## **PALMER'S AIRPORT COMMERCIAL PARK** **SUBDIVISION**

APPLICATION NUMBER 3 DATE December 1, 2022  
 APPLICANT Palmer's Airport Commercial Park Subdivision  
 REQUEST Subdivision

# PALMER'S AIRPORT COMMERCIAL PARK SUBDIVISION

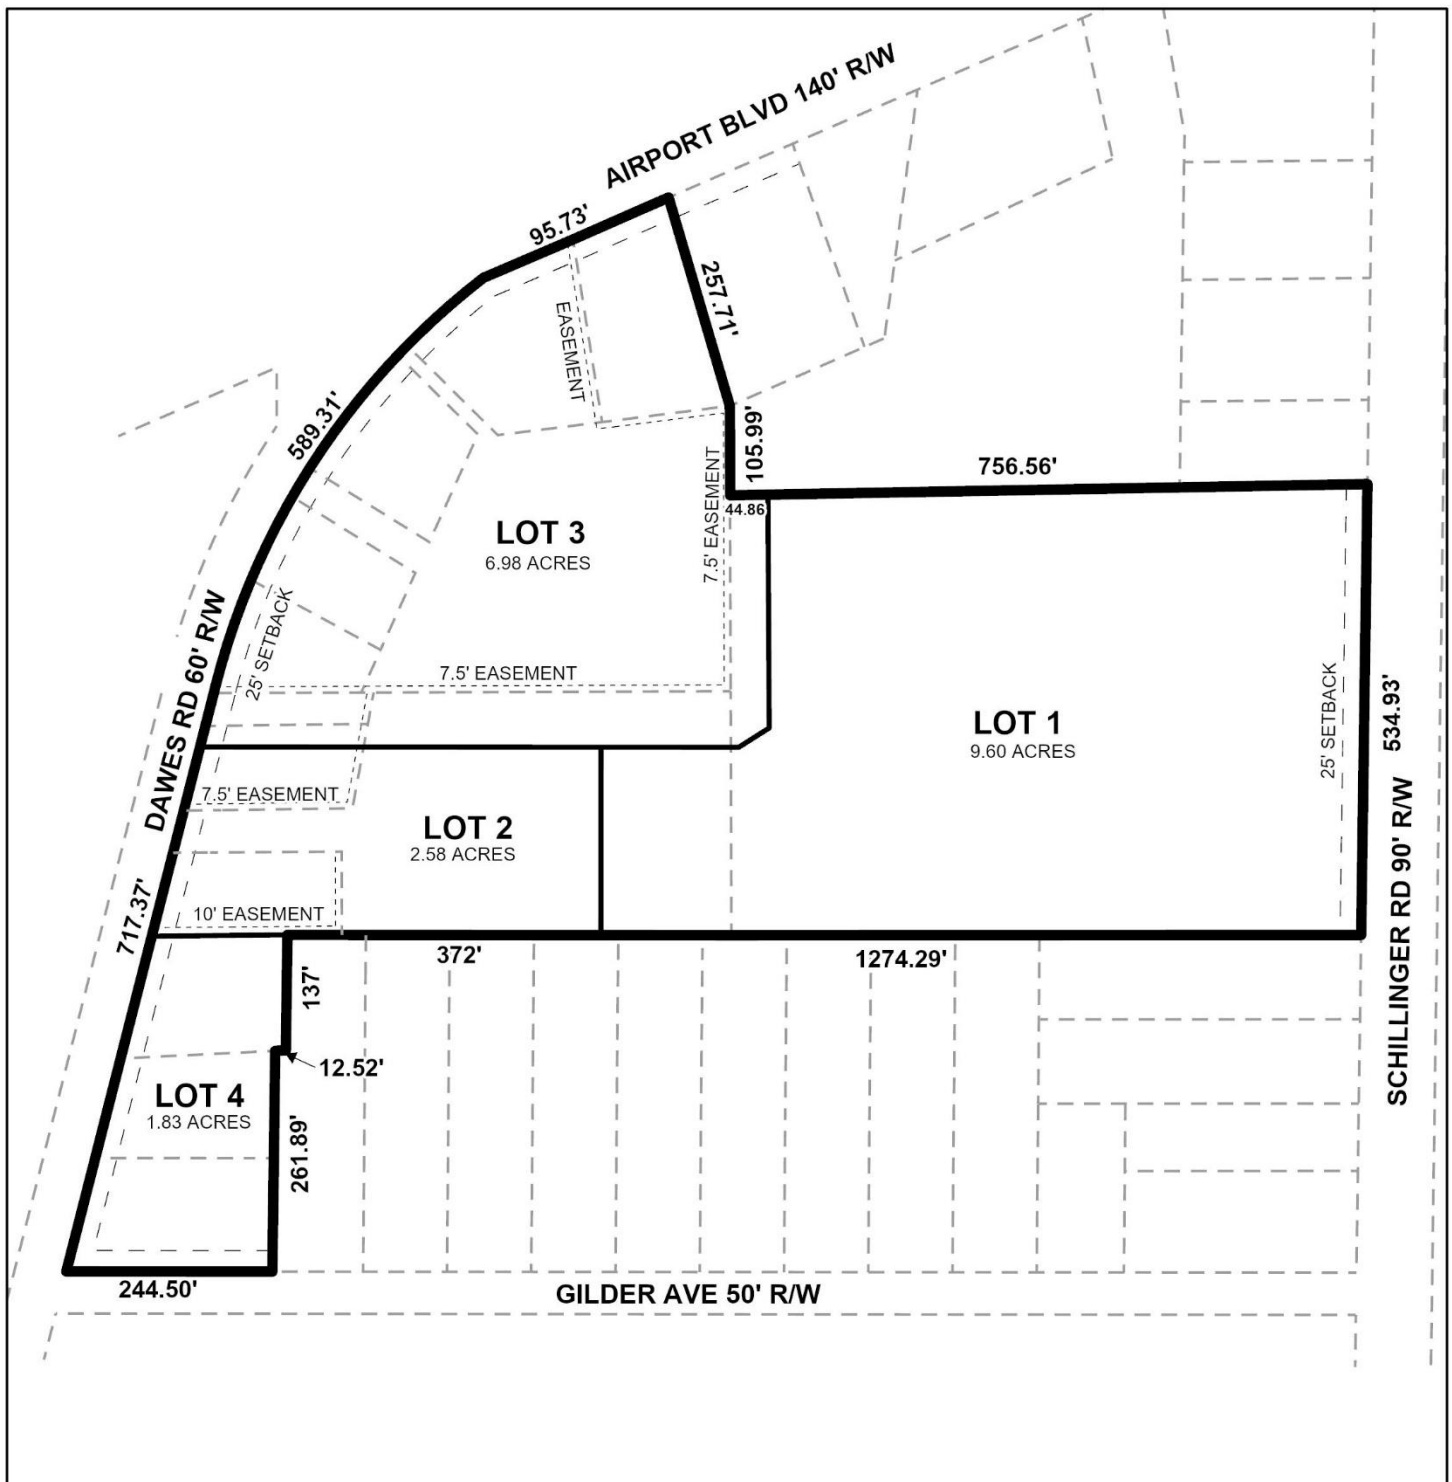
The site has frontage on Airport Boulevard, a major street per the Major Street Plan, which has existing compliant 140-foot right-of-way; therefore, no dedication would be required. As on the preliminary plat, the right-of-way width of Airport Boulevard should be retained on the Final Plat, if approved.

The site has frontage on Dawes Road, a minor arterial street without curb-and-gutter, which has an existing compliant 60-foot right-of-way; therefore, no dedication would be required. As on the

The site has frontage on Glider Avenue, a minor street without curb-and-gutter, which has an existing 50-foot right-of-way and should have a minimum 60-foot right-of-way. Therefore, dedication to provide 30-feet from the centerline of Glider Avenue should be required, if approved.

The site has frontage on Schillinger Road South, a principal arterial street per the Major Street Plan, has an existing 90-foot right-of-way; therefore, dedication to provide 50-feet to the centerline should be required, if approved.

Furthermore, dedication of the corner radius at Dawes Road and Glider Avenue per Section V.D.6 of the Subdivision Regulations should be required, if approved.

The preliminary plat submitted indicates a proposed 25-foot minimum building setback line along Airport Boulevard, Dawes Road, Glider Avenue, and Schillinger Road South, and this should be retained on the Final Plat, if approved.

Based on the preliminary plat, the proposed four (4) lots exceed the minimum size requirements of the Subdivision Regulations. If approved, the lot sizes in square feet and acres on the Final Plat.

The preliminary plat depicts existing drainage and utility easements. If approved, a note should be placed on the Final Plat stating that no structure is allowed in any easement, without the approval of the easement holder.

The preliminary plat contains a note stating that easements along the lot lines of Bates Commercial Park, Resubdivision, Unit One will be extinguished with the recording of this subdivision plat. This should be coordinated with City Engineering prior to signing of the Final Plat.

It should be noted that proposed Lots 1 and 2 have existing shared access that may have existed prior to the site being annexed into the City of Mobile in 2007. If any new development of the property is proposed, the site will need to comply with the Zoning Ordinance requirements.

As illustrated the submitted plat meets the minimum requirements of the Subdivision Regulations and is recommended for Tentative Approval subject to the following conditions:

- 1) dedication to provide 50-feet to the centerline of Schillinger Road South;
- 2) dedication of corner radius at the corner of Dawes Road and Glider Avenue;
- 3) dedication to provide 30-feet to centerline of Glider Avenue;
- 4) retention of the right-of-way widths of Airport Boulevard and Dawes Road;

- 5) retention of 25-foot minimum building setback line along public frontages, adjusted for dedication on the Final Plat;
- 6) coordination with City Engineering to relocate the existing easement and extinguish the existing one prior to the signing of the Final Plat;

- 7) placement of a note should be placed on the Final Plat stating that no structure is allowed in any easement, without the approval of the easement holder;
